## Quick Change Tamper Upgrade

TIP MWU\_2601

Folio Sheeters

**Machine Model for Improvement:** TSKM, Wizard, and Hawk Sheeter

After Upgrade

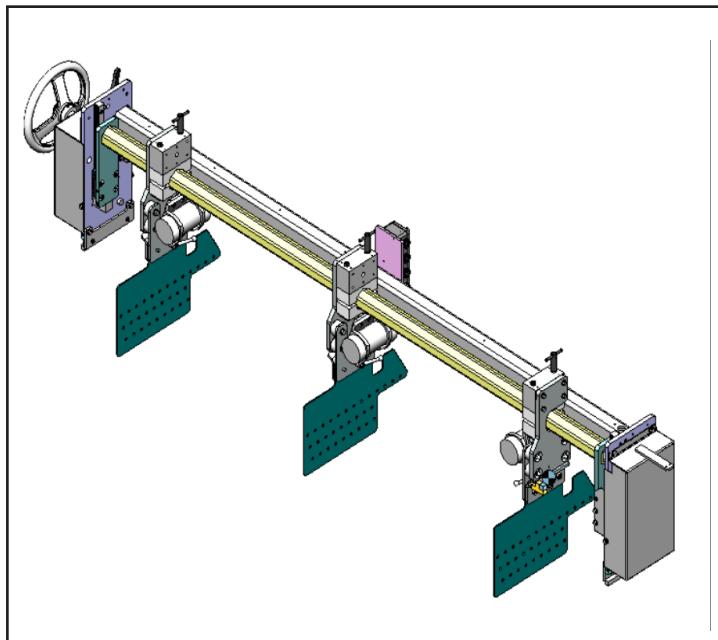
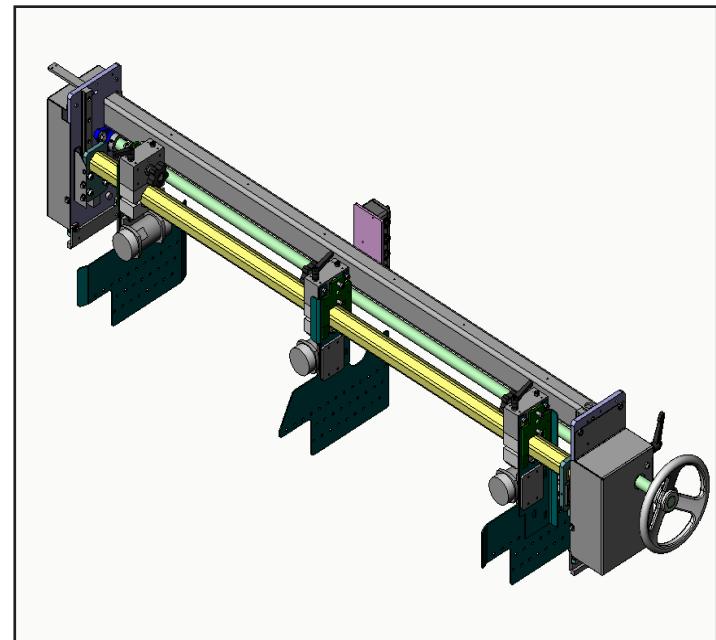
This upgrade was designed to reduce weight for operators as well as reduce order change time. The new design incorporates the electric vibrator to the mounting clamp and uses rubber isolators to improve the effective vibration into the tamper blade.

Additionally, this reduces the weight and time since the vibrator is no longer attached.

Included is a new tamper carriage, clamp, vibrator, and sets of tamper blades to match existing lengths, along with any necessary engineering, installation instructions, and documentation updates
